Dewberry Response to USGS Review of the Virginia FEMA NRCS South Central LiDAR Project– Block 1

Produced for U.S. Geological Survey

USGS Contract: G16PC00020
Task Order: G17PD01206
Report Date: 08/22/2019

Figure 2 - Tile 17SLC64500750. The image on the left shows the DEM where USGS made a missing data call. The image on the right is an overview of the DEM after Dewberry clipped the tile to the project boundary.

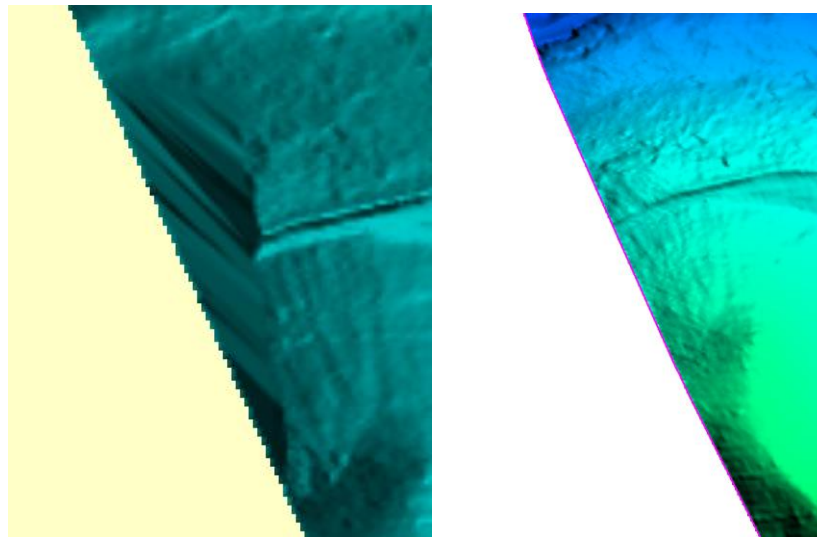
USGS made two calls for missing data. One call was on the edge of the project, that ground could be added. The other was an area of dense tree cover and there were no ground points that could be replaced. Dewberry corrected the issue with the missing ground along the edge of the project.

Figure 3 - Tiles 17SNA68506650. At left, a USGS screenshot of part of a bridge classified as ground. At right, the bridge has been removed from the Lidar and DEM.

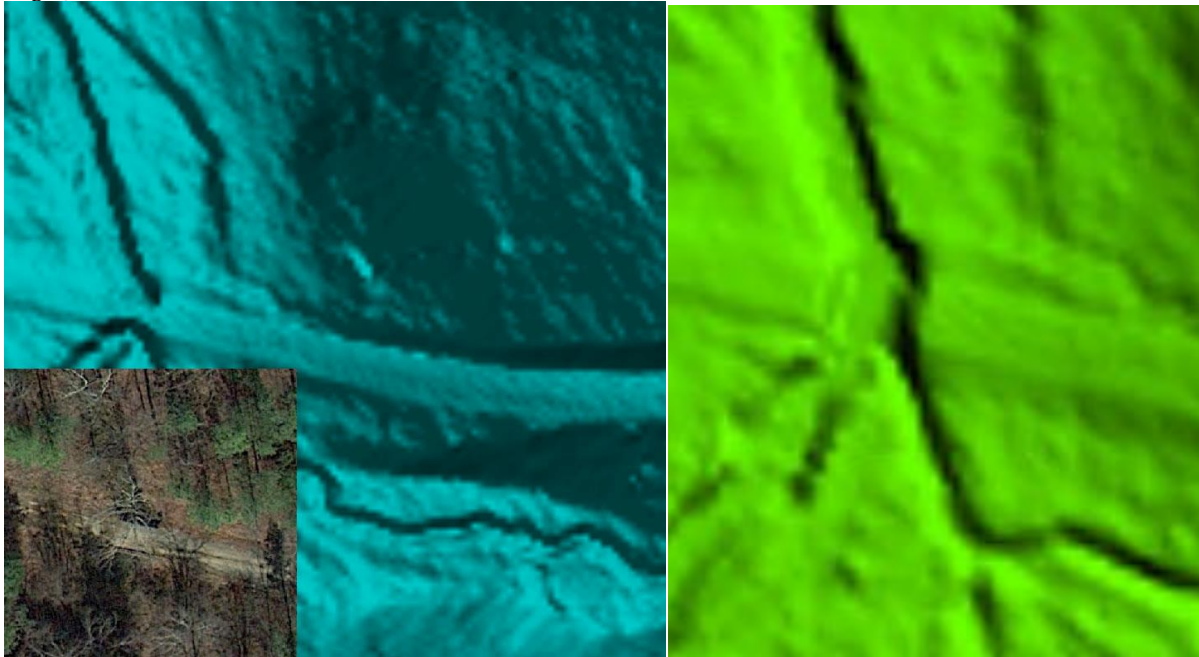
USGS identified twenty-five bridge and culvert calls. The bridge points were reclassified from ground to bridge deck while the culverts had points returned to ground. The LAS was reclassified and the DEMs and contours updated. Examples are shown below.

Figure 5 - Tiles 17SLC97501350 (Top) and 17SNB25000100 (Bottom) are pictured above. The top pair of images shows USGS screenshot of low points on the left and the Dewberry correction on the right. The bottom pair shows the USGS screenshot of a spike and the right the Dewberry correction.

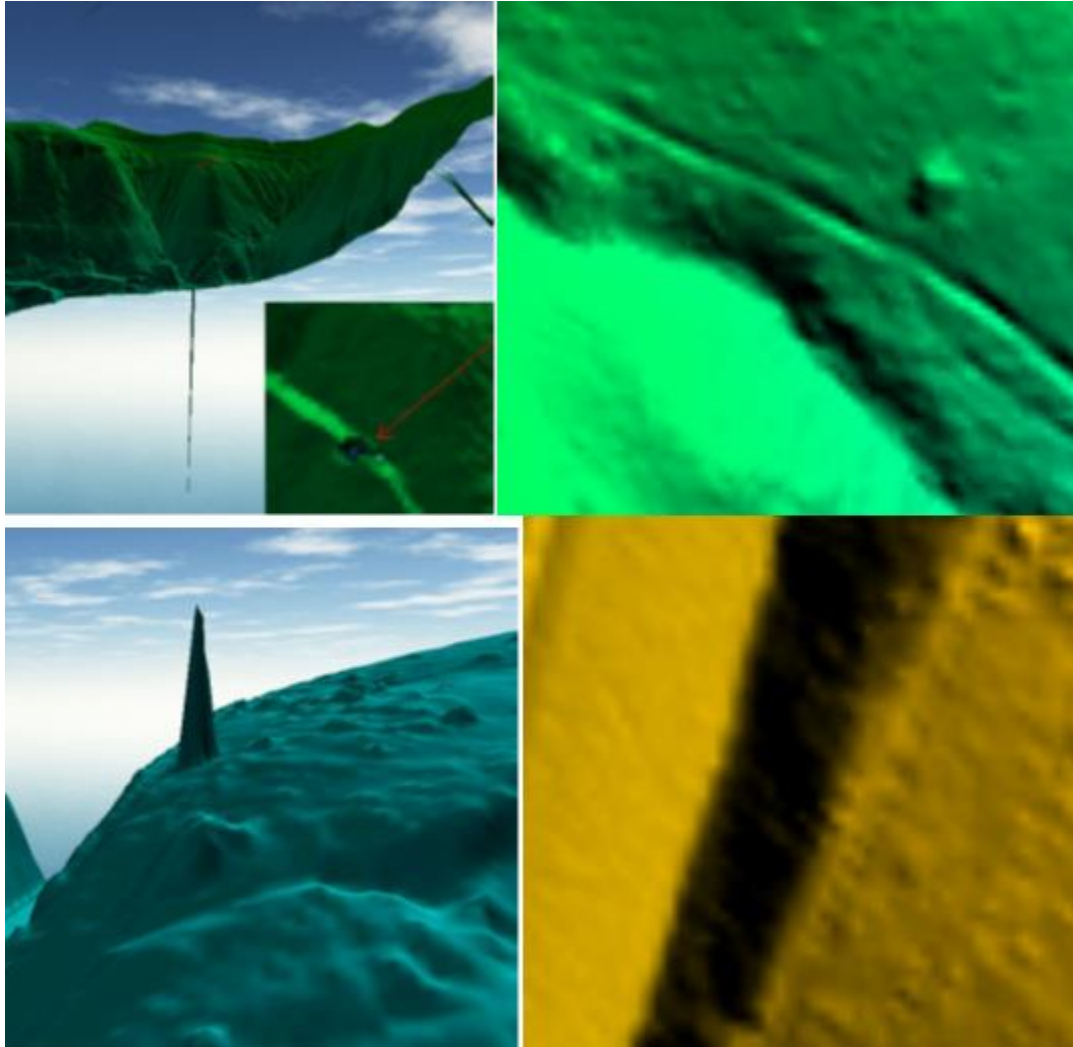
USGS identified 134 spikes and divots that needed to be removed from the ground. The edit calls were assessed and corrected. An example is provided below.

Figure 6 - Tile 17SNA41509950. The pond shown was identified by USGS as over 2 acres and needed to be hydro-flattened (left). The LAS and DEM have been corrected by adding breaklines and hydro-flattening (right).

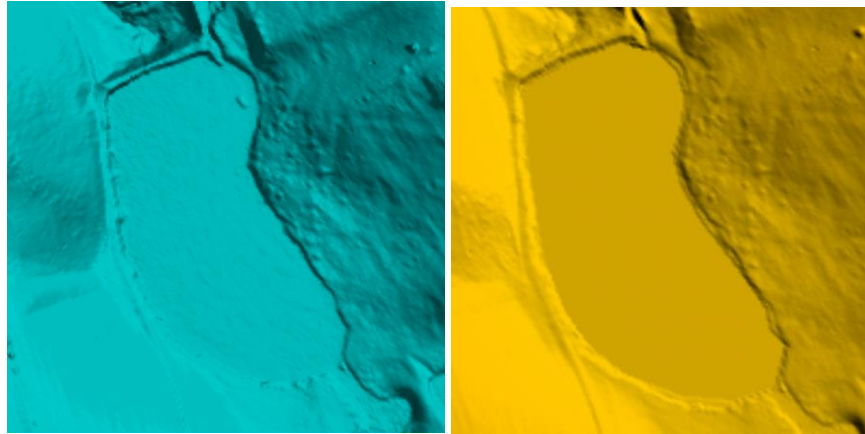
USGS identified thirty-eight hydro-flattening/water level calls, three hydrographic artifact, and a call to raise all river breaklines by 3'. They hydro flattening/water level calls were addressed as well as the artifacts but to maintain monotonicity and to keep the rivers from floating the call for raising the breaklines by 3' systematically was not an option. Examples are shown below.

Figure 10 - Tile 17SNB41501300. The top two screenshots are from USGS called “Check for Trees in Orchard.” Dewberry found that these artifacts are mounds and that no points could be removed from ground. The bottom screenshot shows the ground (orange) and unclassified (grey) points.

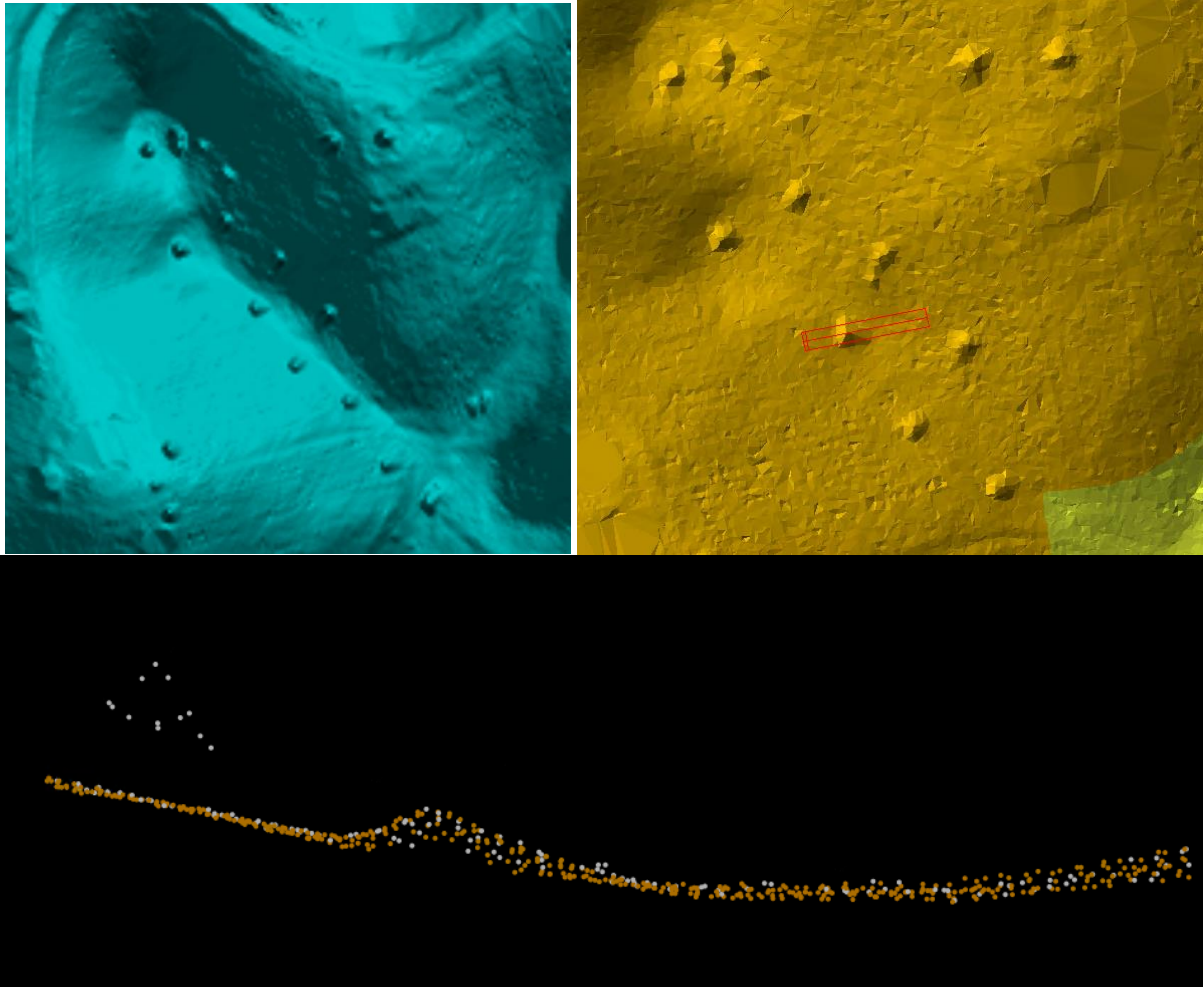
USGS identified eight artifacts to be removed from ground. Six of the calls pertained to the orchard as shown below. Dewberry found all of these areas to be an accurate representation of the ground. No updates to the Lidar/DEM were made.

Figure 11 – Tile 17SLC96008100. USGS call to return points to ground on the top left, Dewberry updates shown on the top right. The bottom shows a cross-section of the points where many points could be returned to ground (orange) from unclassified (grey).

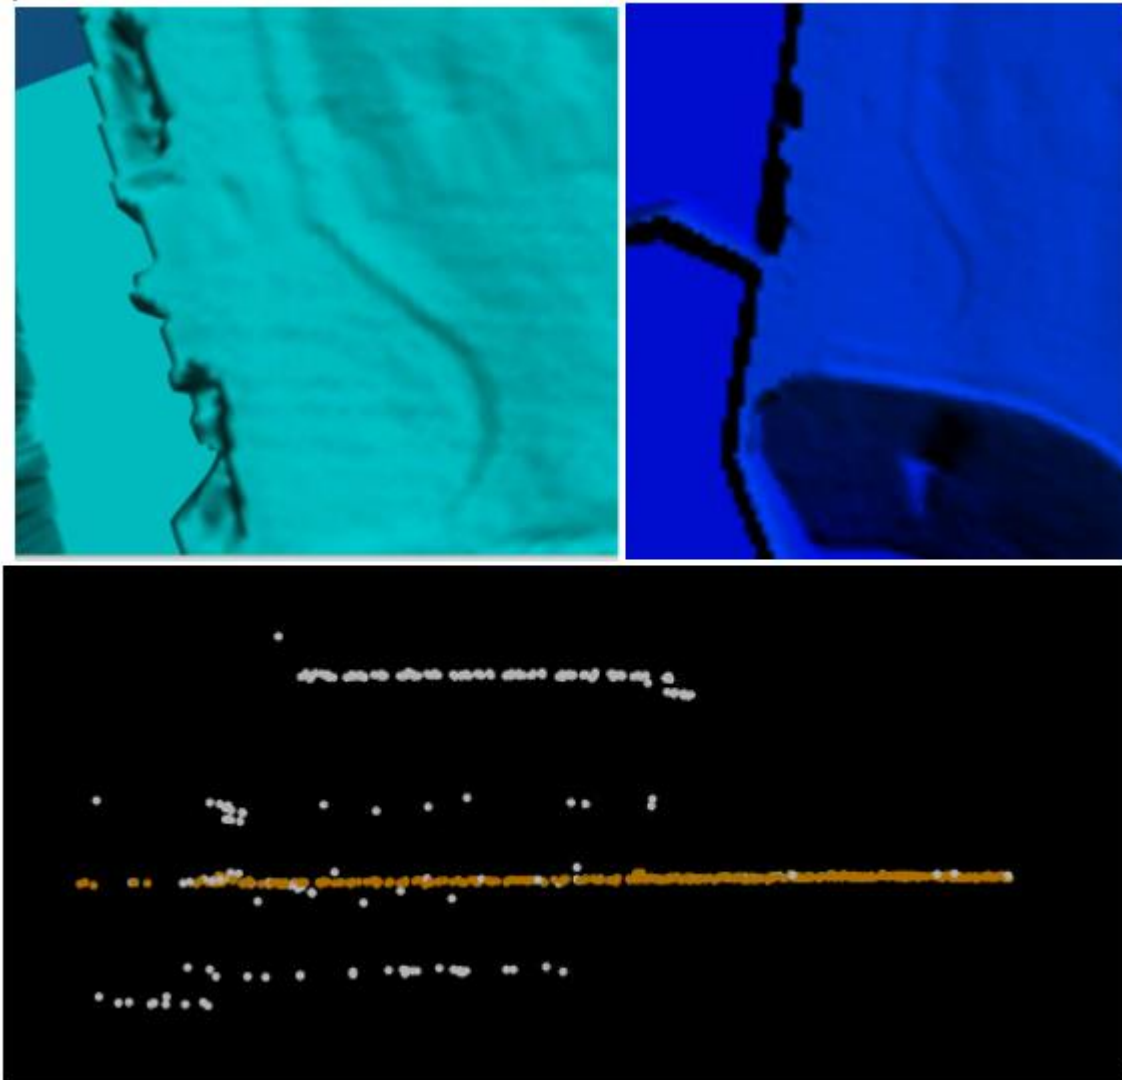
USGS identified ten areas where points needed to be returned to ground. Nine of the calls were addressed; one call did not have any points that could be moved. An example is show below.

Figure 12 – 17SMC00503150. USGS call for cornrowing shown on the left. The Dewberry update is shown on the right. The cornrows have been smoothed out in the ground surface.

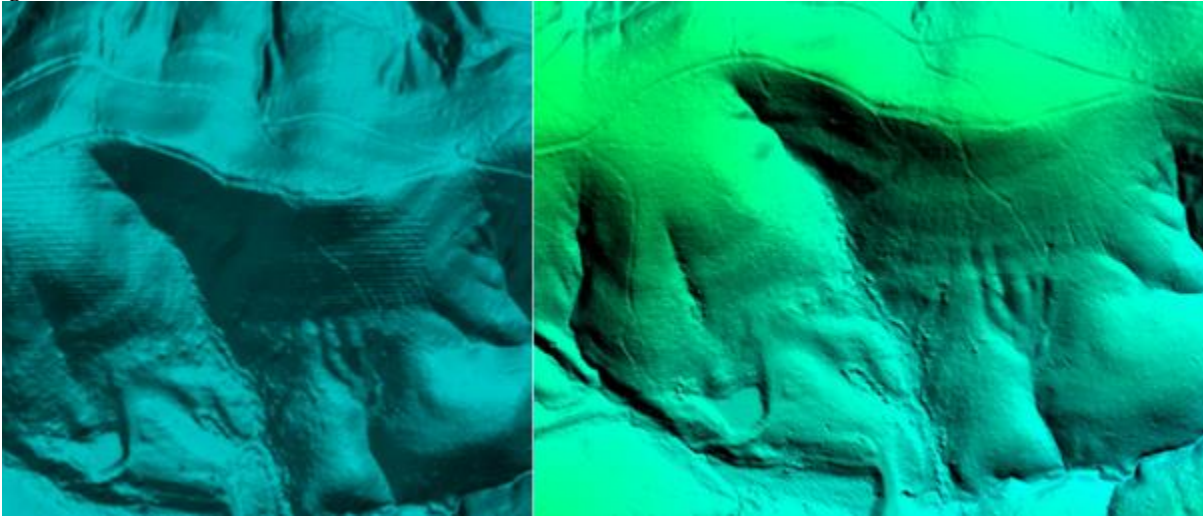
USGS identified four areas where there were some anomalies in the ground surface. An example is show below.
